WATTS BAR NUCLEAR PLANT (WBN) - FINAL SAFETY ANALYSIS REPORT (FSAR)
CHAPTER 12, AMENDMENTS 54 - 63 (TAC NOS. 63647 AND 77061)

WATTS BAR NUCLEAR PLANT (WBN)
RESPONSE TO REQUEST FOR ADDITIONAL INFORMATION (RAI)
CHAPTER 12 UPDATES TO FINAL SAFETY ANALYSIS REPORT (FSAR)
AMENDMENTS 54 THROUGH 63

CHAPTER 12 WATTS BAR FSAR REVIEW
REQUEST FOR ADDITIONAL INFORMATION

TABLE 12.3-2

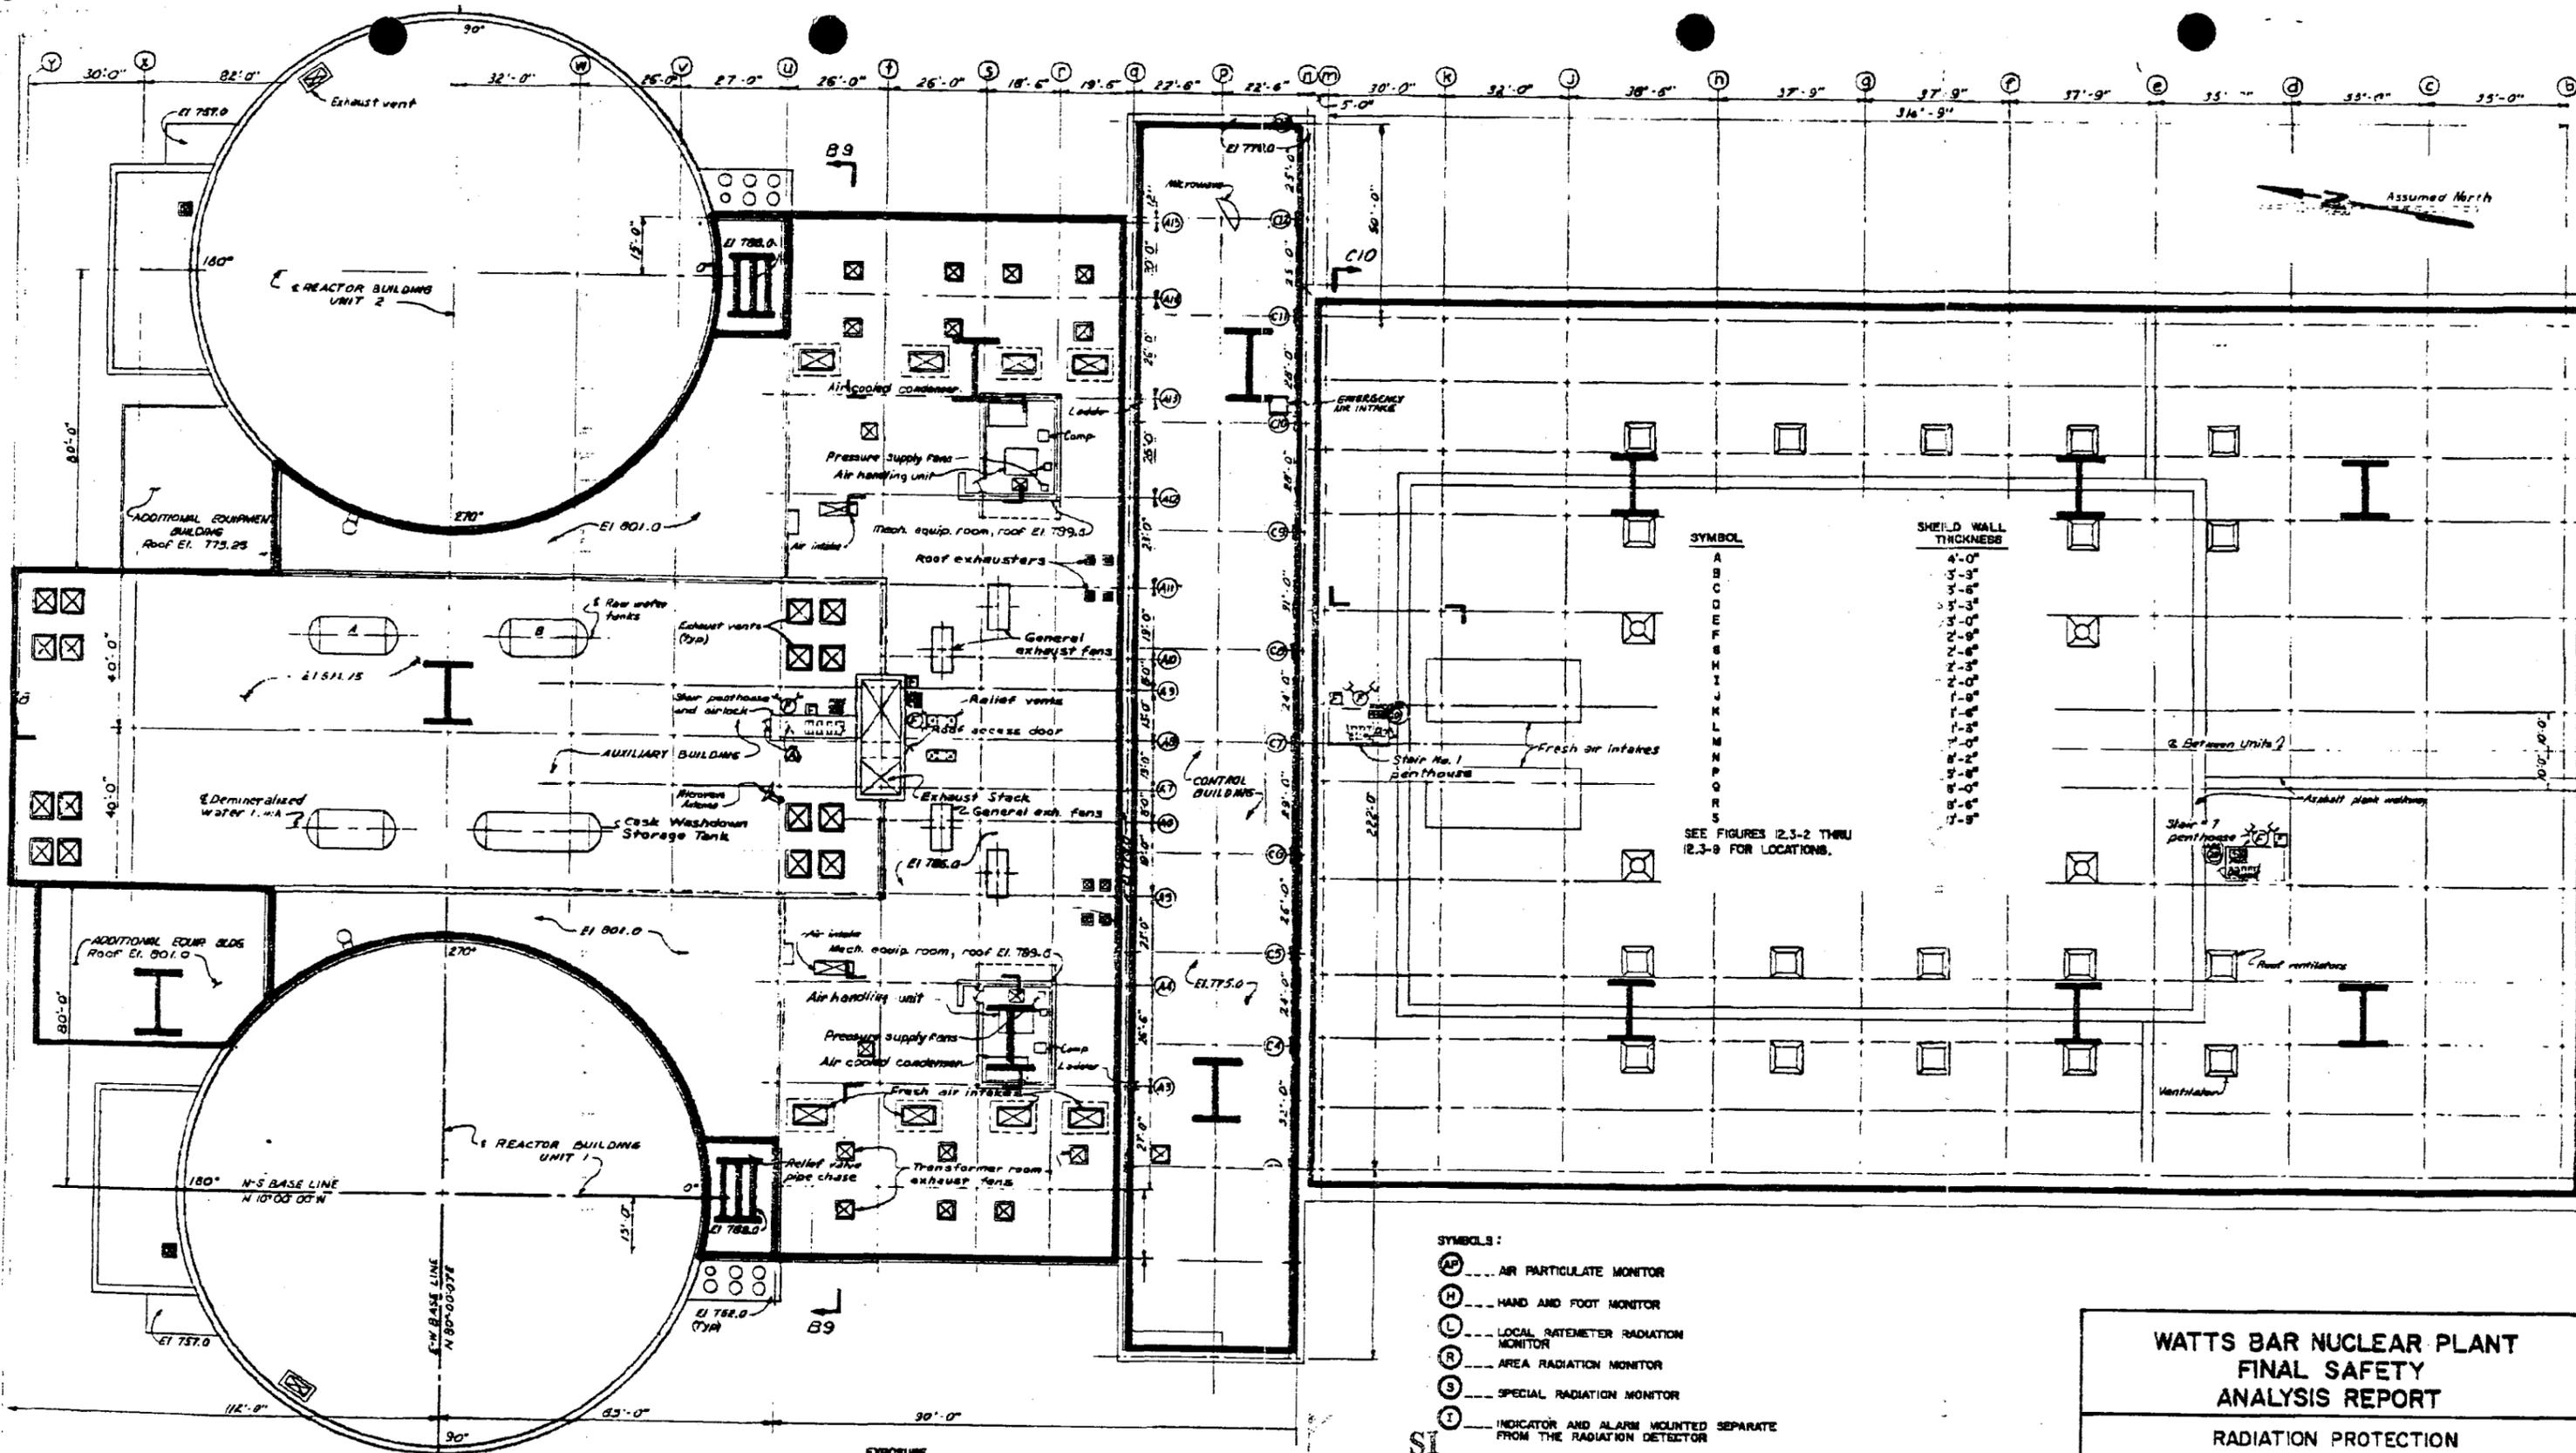
Provide the basis for determining that this alternative control is adequate. Also, Section 12.5.3 is inconsistent with notes on Table 12.3-2 "Access Control Areas." Resolve this discrepancy.

A proposed revision of Table 12.3-2, "Access Control Areas," is attached to resolve inconsistencies with other information provided in the FSAR. This revised table or a similar change will be incorporated in a future FSAR amendment. Areas in the plant that exceed 100 mr/hr are identified by Zones IV and V on Figures 12.3-1 through 12.3-8 and 12.3-11. Updated versions of these figures are attached. Note that the versions of Figures 12.3-1, 12.3-3, and 12.3-4 which are currently in the FSAR inadvertently omitted radiation zone identifications. The latest figures will be incorporated into a future FSAR amendment.

4. The area is conspicuously posted with a sign or signs bearing the radiation caution symbol and the words, CAUTION HIGH RADIATION AREA. At each entrance is a solid or wire mesh door which is maintained locked except when access to the area is required. Entry is under administrative control. The door can always be opened from the inside. Large areas, such as PWR containment, where no enclosure exist for purposes of locking, and where no enclosure can be constructed around the individual/area shall be barricaded, conspicuously posted and have a warning device such as a flashing light.

FIGURE 12.3-5

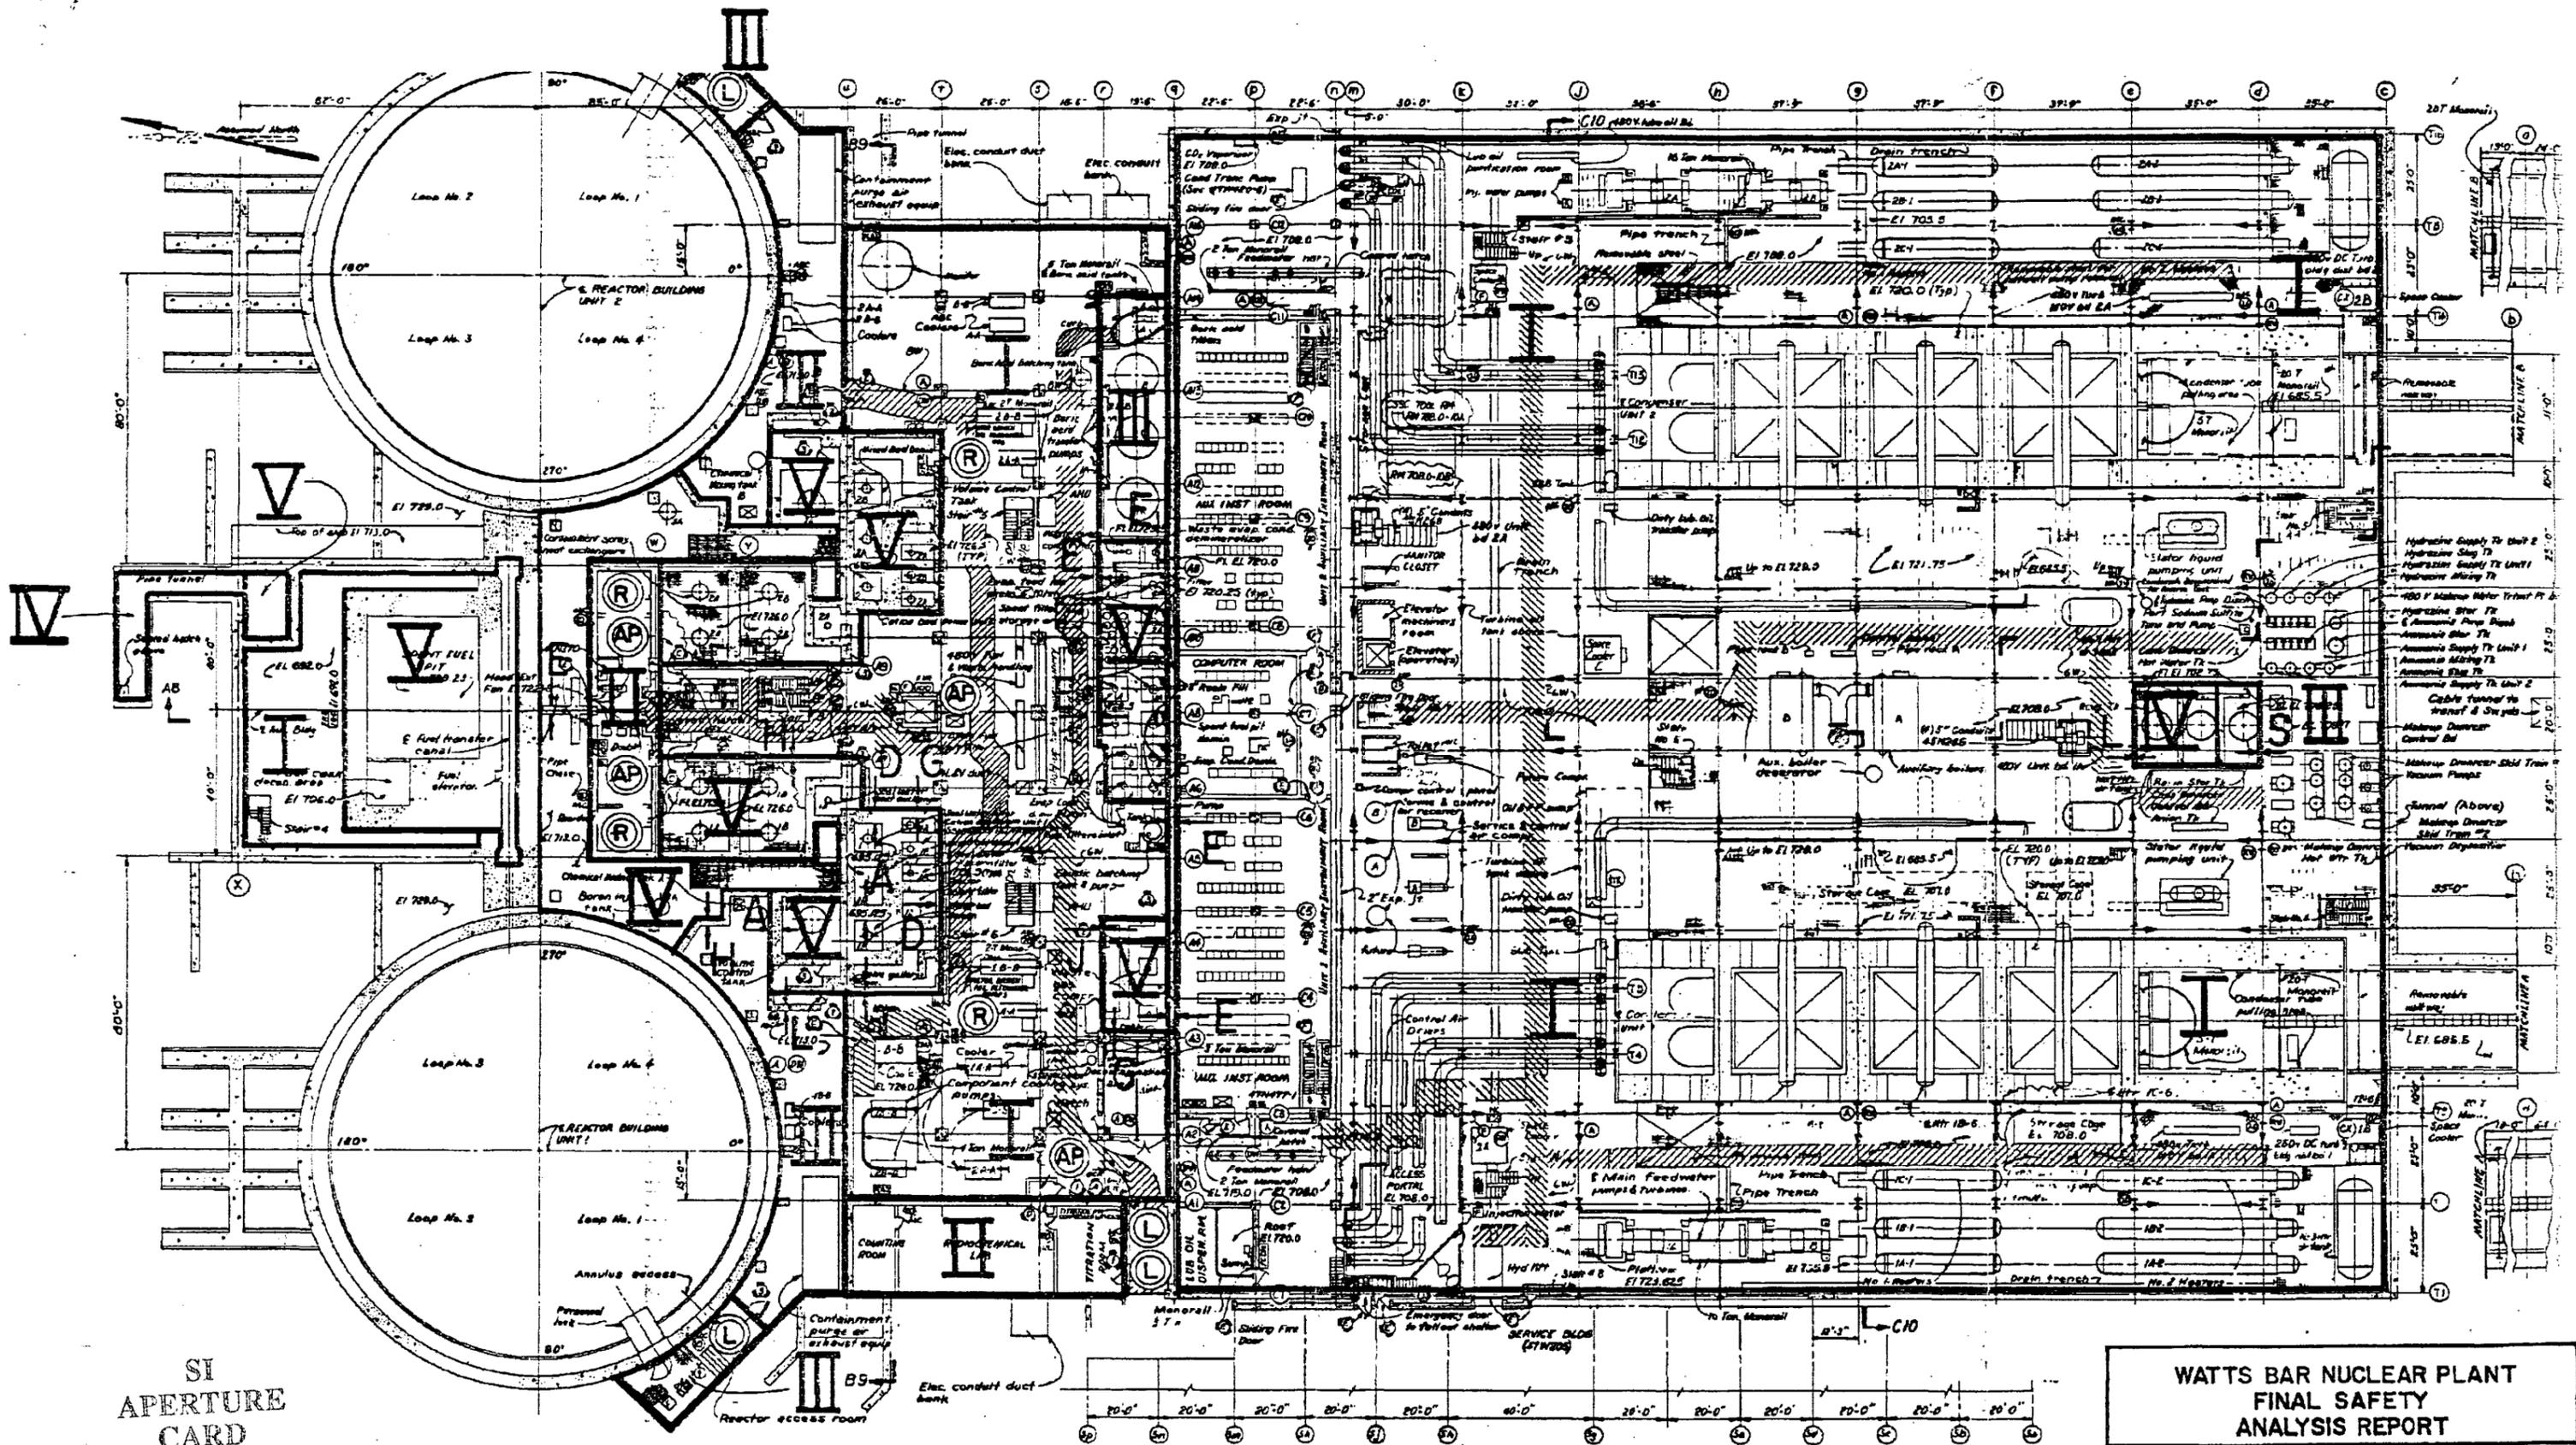
Figures 12.3-5 and 12.3-6 appear to indicate two accessible areas in the auxiliary building adjacent to the spent fuel transfer tube. Figure 12.3-5 shows accessible areas on the 729.0-ft elevation just outside the reactor buildings (near the 270° point). Figure 12.3-6 shows two passageways leading to the cask decon equipment that pass just below the transfer canal (692.0-ft elevation).

Provide an estimate of the peak dose rate in these areas during transfer of "fresh" spent fuel bundles.

Fuel transfer shielding is described in FSAR Section 12.3.2.2, beginning on page 12.3-12 (as of Amendment 64). As stated in this section, 5 ft - 6 in of concrete shielding around the spent fuel transfer canal will reduce the dose rate during fuel transfer to less than 5 mrem/hr in adjacent areas. In the auxiliary building areas on elevations 692.0 ft and 729.0 ft which are adjacent to the fuel transfer canal, there is at least 5 ft - 6 in of concrete shielding around the canal. Accordingly, the dose rate will be less than 5 mrem/hr during spent fuel transfer. The only high radiation area generated by the transfer of spent fuel is in the emergency passageway underneath the transfer canal inside containment where the dose rate could be as high as 210 mrem/hr (see FSAR page 12.3-14). This area is not readily accessible.
